MAYFLOWER PLATINUM

Details of Additions & Alterations

Flat No	1007	Block no.	'A'
Flat Area	1800 sft	Type	Deluxe / Luxury
Buyer Name	Abhinav Bollepali		
Phone No.	90354281	Email	abhinavchowday.1507@gmail.com

Description	Direction	Owners & Developers :	Date :	18.03.2020	Promoted by
WORKING DRAWING OF FLAT.NO.A-7		Modi Properties Pvt Ltd.	Prepared By :		Modi Properties Pvt. Ltd Phone:+91-40-66335551
		Project Name & Phase :	Approved By :	Soham Modi	
		MAYFLOWR PLATINUM	Scale :	N.T.S

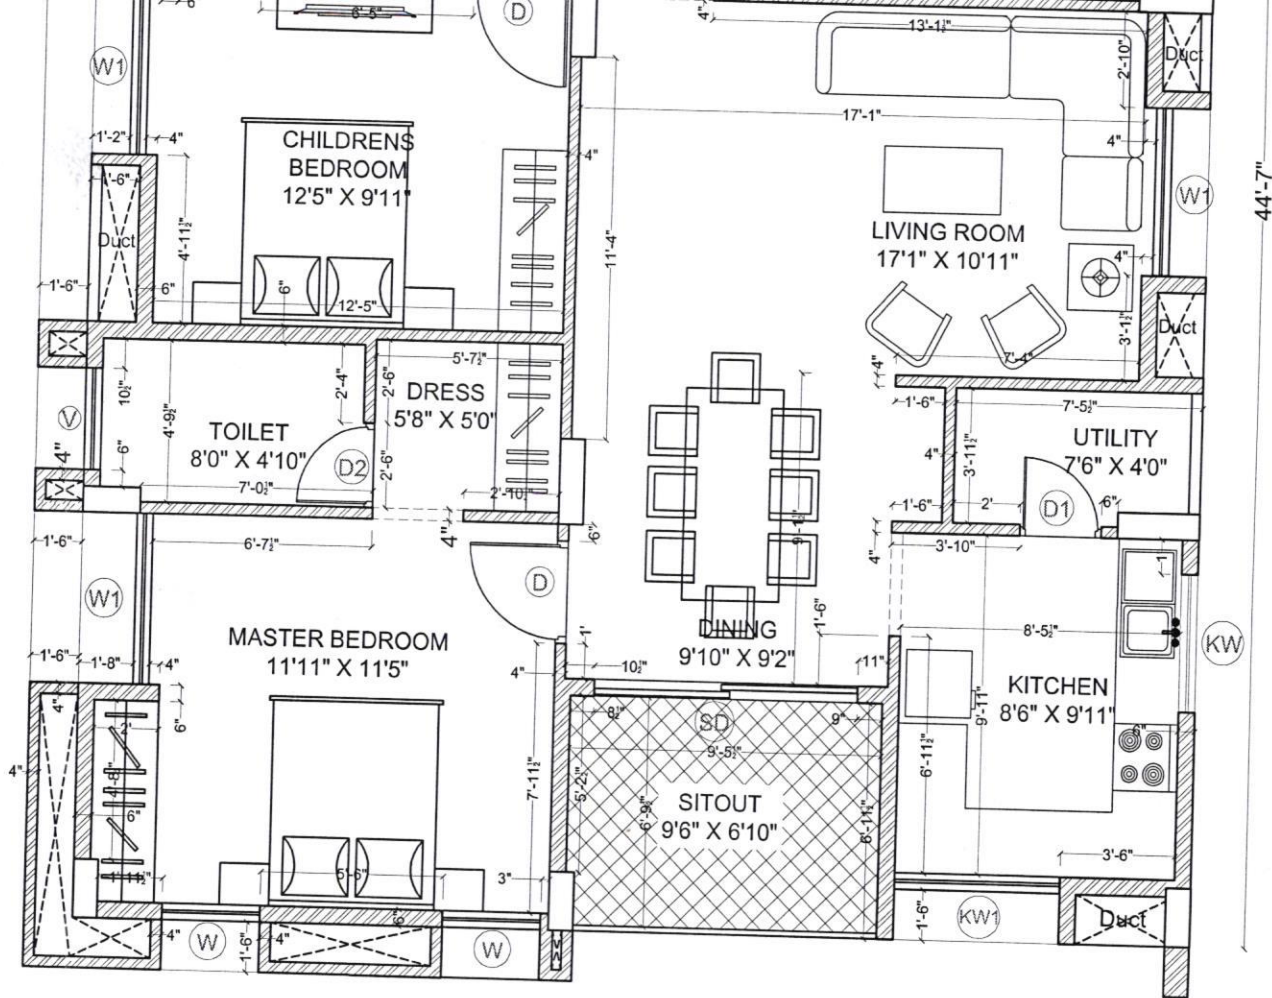
Changes in kitchen platform: (mark on plan)

Reorder 10/11

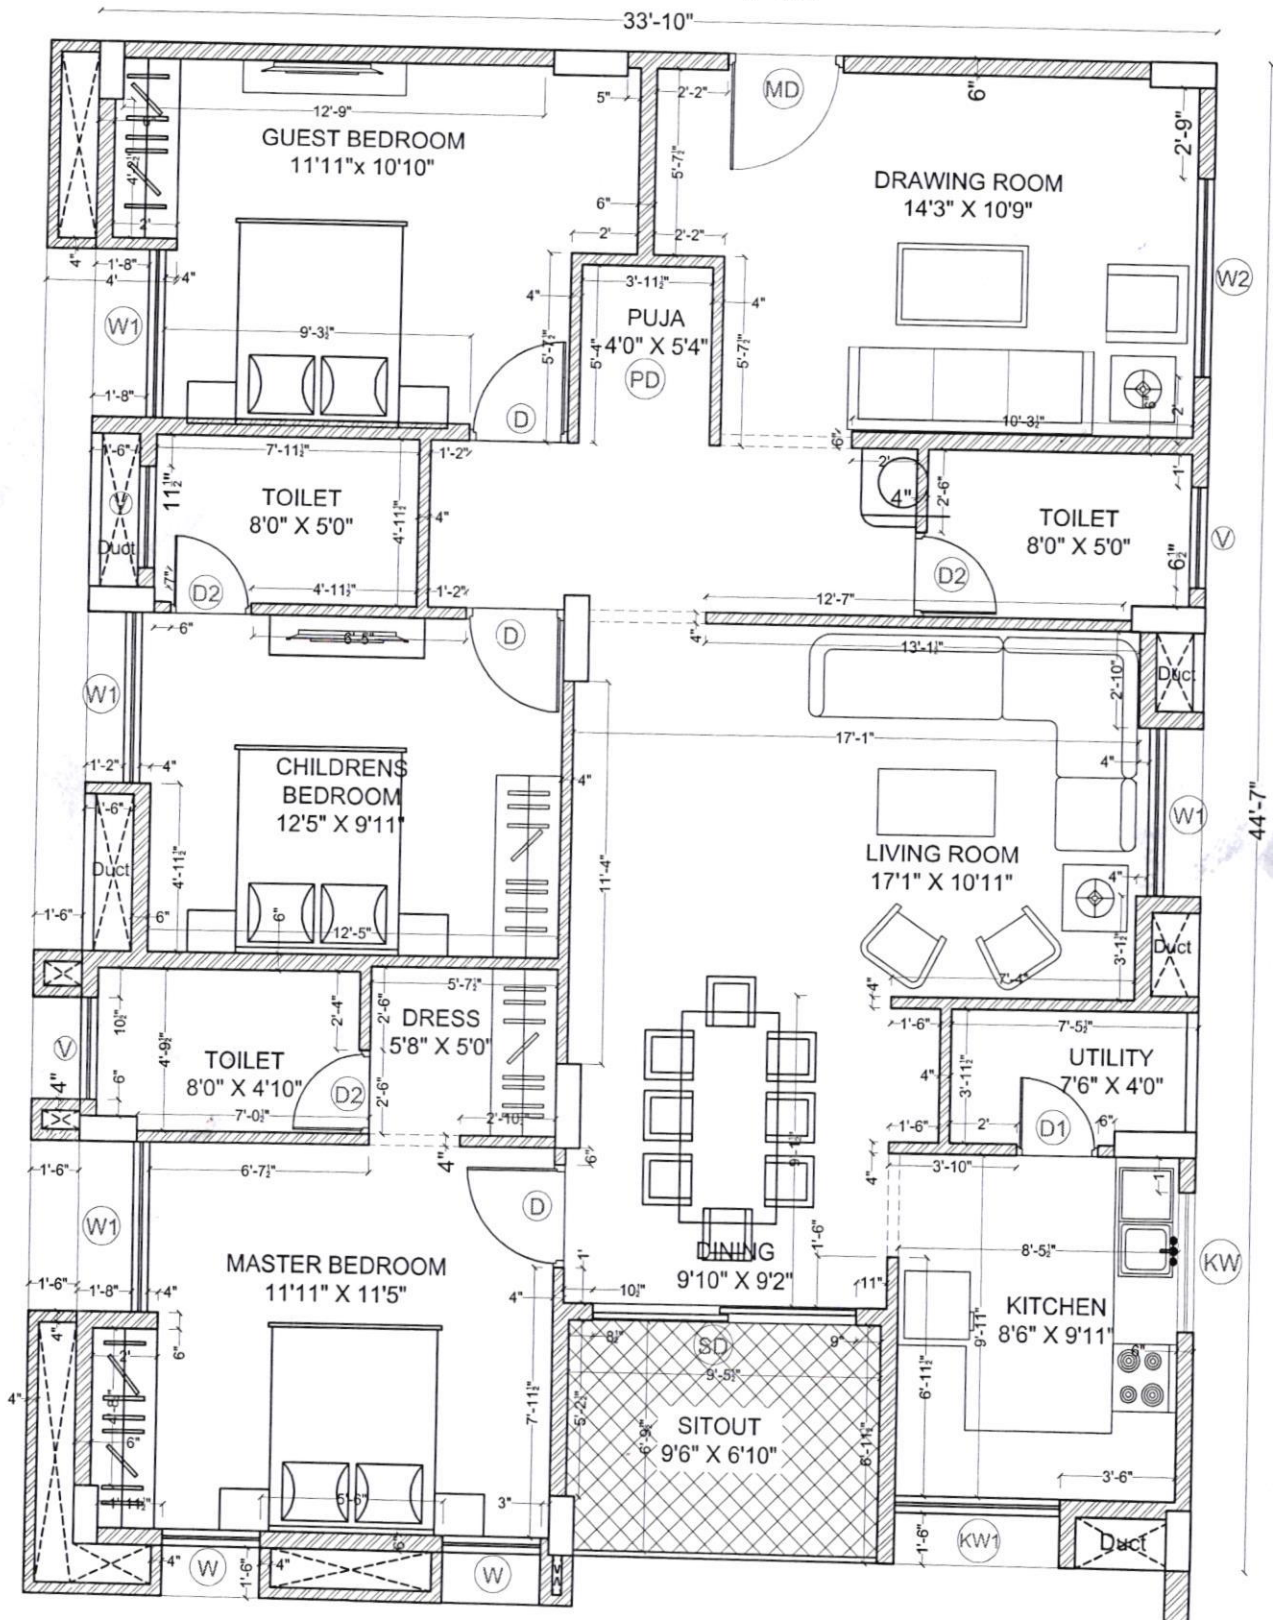
Changes in electrical points: (mark on plan)

- marked on plan
